Project Name	Layout Title	Revisions	Scales @ A3	Drawing Number	Rev
Chantry Centre, Dursley	Consented and Proposed Elevations		1:100	24-1-06	01

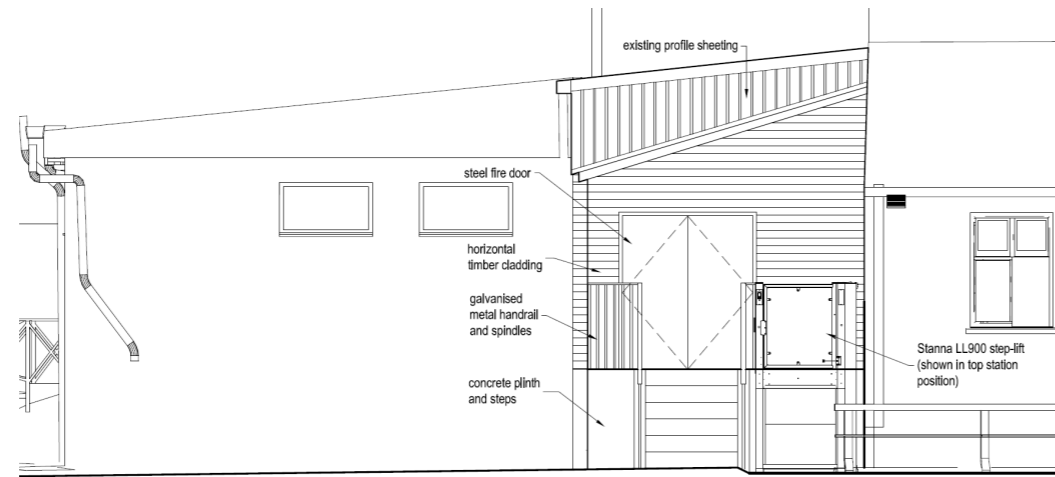
Elevation shows access ramp including amended contours to ground level to ensure ramp gradient compliant with regulations.

Elevation shows platform/step lift. No changes needed to existing ground level. Building finish unchanged save horizontal rather than vertical cladding.
